#### APPEAL SUMMARY

<b>Appeal ID:</b> 24645	<b>Project Address:</b> 5270 SE 18th Ave
<b>Hearing Date:</b> 2/24/21	<b>Appellant Name:</b> Steve Fosler
<b>Case No.:</b> B-009	<b>Appellant Phone:</b> 503 241 9339
<b>Appeal Type:</b> Building	<b>Plans Examiner/Inspector:</b> Chanel Horn
<b>Project Type:</b> commercial	<b>Stories:</b> 3 <b>Occupancy:</b> R-2 <b>Construction Type:</b> V-B
<b>Building/Business Name:</b> MKBL 1	<b>Fire Sprinklers:</b> Yes - throughout
<b>Appeal Involves:</b> Erection of a new structure	<b>LUR or Permit Application No.:</b> 19-234704-CO
<b>Plan Submitted Option:</b> pdf [File 1] [File 2] [File 3] <b>Proposed use:</b> apartments

#### APPEAL INFORMATION SHEET

F-3	GA FILE NO. FC 5109	PRESCRIPTIVE
	1 HOUR FIRE	55 - 59 STC
	FLOOR/CEILING AT EXTERIOR PATIO LOCATIONS

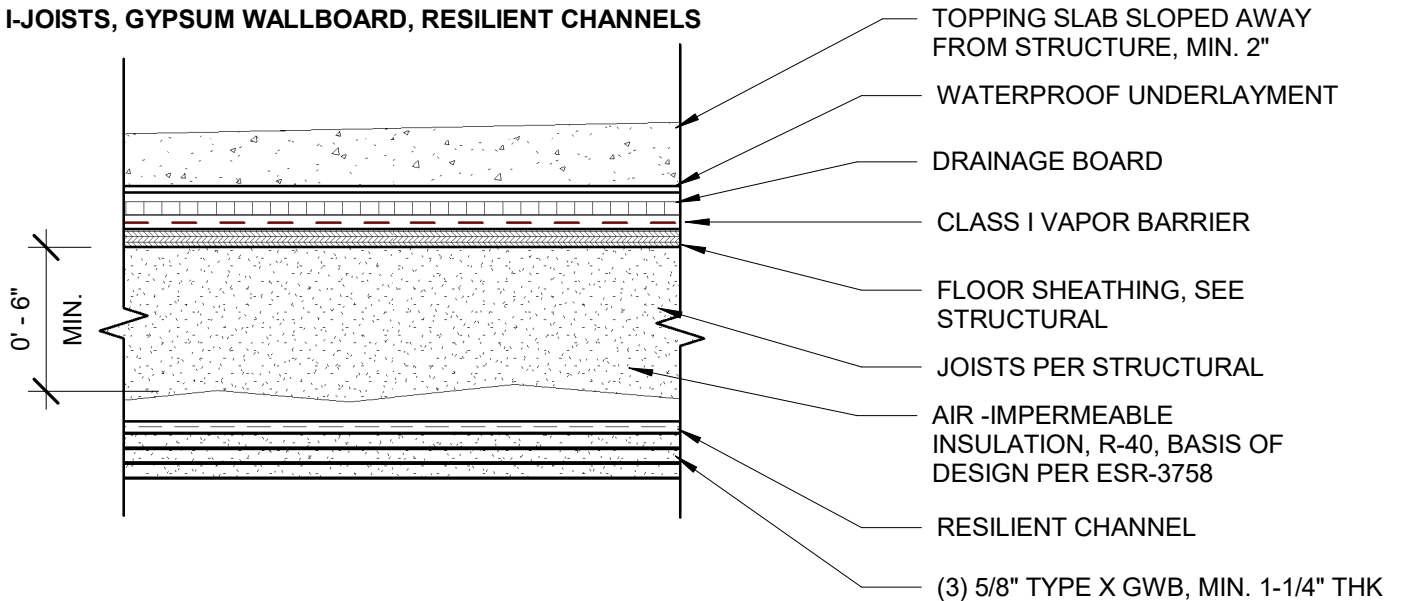
<b>Code Section</b>	OSSC 2014, Section 1203.1
<b>Requires</b>	Enclosed rafter spaces formed where ceilings are applied directly to the underside of framing members shall have cross ventilation for each separate space by ventilation openings protected against the entrance of rain and snow. An airspace of not less than 1 inch shall be provided between the insulation and the sheathing.
<b>Code Modification or Alternate Requested</b>	Project proposes an unvented rafter space assembly conforming to OSSC 2019, section 1202.3 for decks located above occupied spaces.
<b>Proposed Design</b>	<p>The proposed unvented rafter space is as follows per 1202.3 (2019 OSSC)</p> <ol style="list-style-type: none"> <li>1.The unvented rafter space is completely within the building thermal envelope.</li> <li>2.No interior Class 1 vapor retarder will be installed on the ceiling side of the unvented rafter framing assembly.</li> <li>3.Wood shingles or shakes are not used.</li> <li>4.Foam-in-place, air impermeable insulation shall be a Class II vapor retarder and is applied in direct contact with the under side of the structural roof sheathing. Total R-value shall exceed 10 for condensation control.</li> <li>5.1.1 Where only air-impermeable insulation is provided it is applied in direct contact with the underside of the sheathing</li> </ol>

<b>Reason for alternative</b>	<p>Project is reviewed under OSSC 2014.</p> <p>The proposed assembly satisfies provisions of the OSSC 19, section 1202.3 for unvented attic and unvented enclosed rafter assemblies, that is currently ratified under Oregon Law.</p>

**Unvented attic space: Granted as proposed per Detail F3.**
